Road Safety Audit:

County Route 533 and County Route 527
Downtown Bound Brook Borough, Somerset County
(Tea Street to Railroad Avenue)

This document is the draft report of the County Route (CR) 533 and CR 527 Road Safety Audit (RSA). It was conducted along CR 533 (Talmage Avenue, Columbus Place and Main Street) Tea Street to Mountain Avenue and CR 527 (East Main Street) from Mountain Avenue to Railroad Avenue in Bound Brook Borough, Somerset County. Of note, during the field visit, the attendees also discussed the intersection of CR 533 and E. High Street, located east of the roundabout. An RSA is an effective way of identifying crash-causing trends and appropriate countermeasures utilizing a nontraditional approach that promotes transportation safety while maintaining mobility.

SITE PHOTOGRAPHS

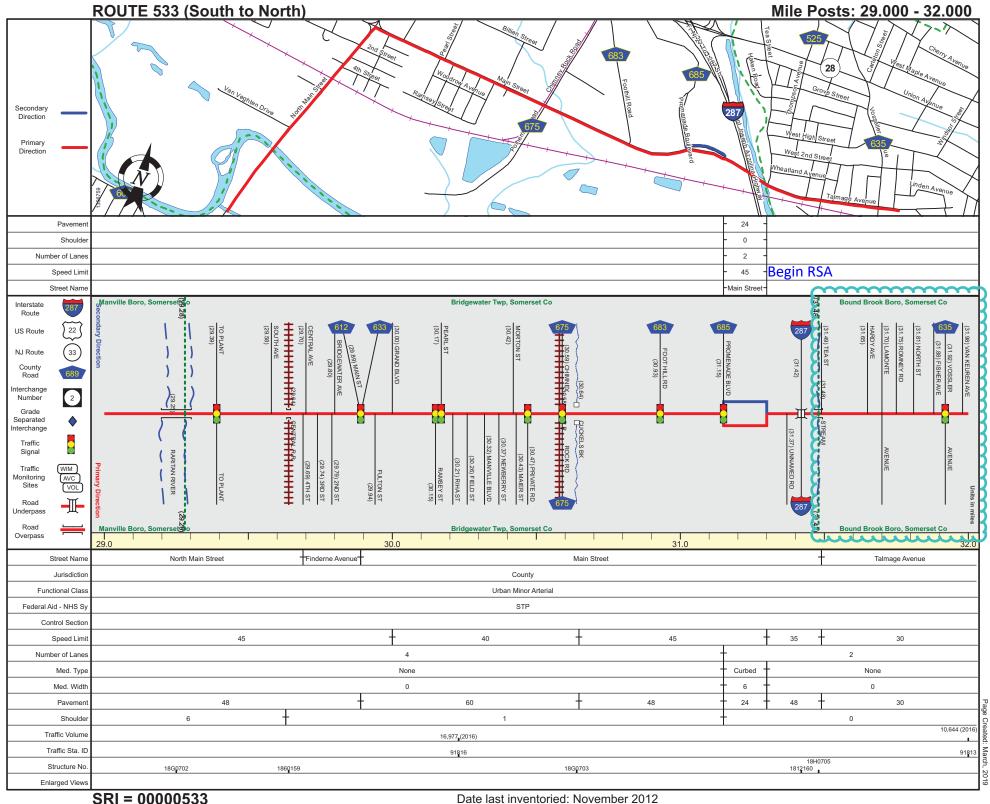
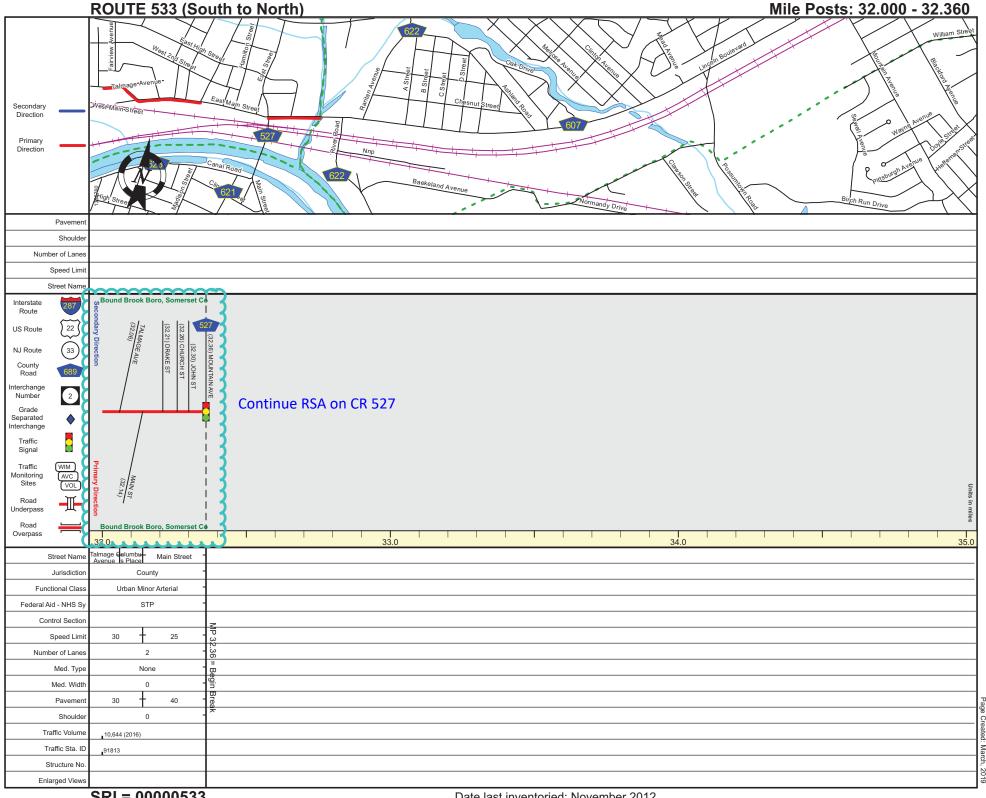
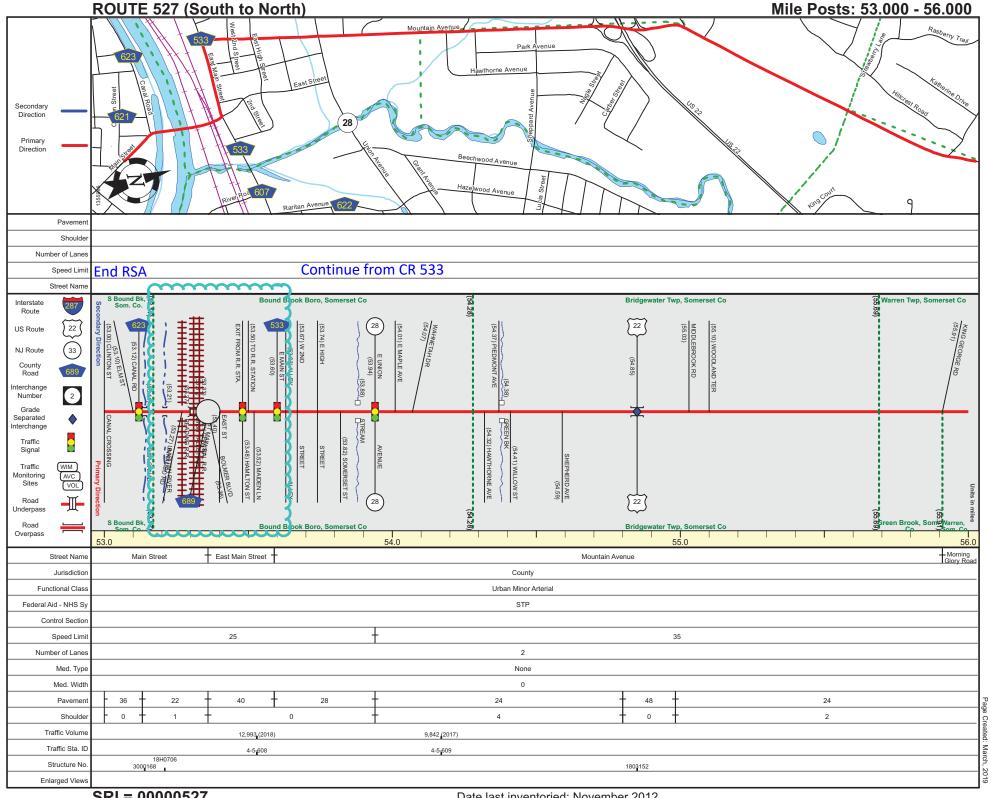
Low roundabout splitter islands do not provide sufficient definition or refuge and lack detectable warning surfaces
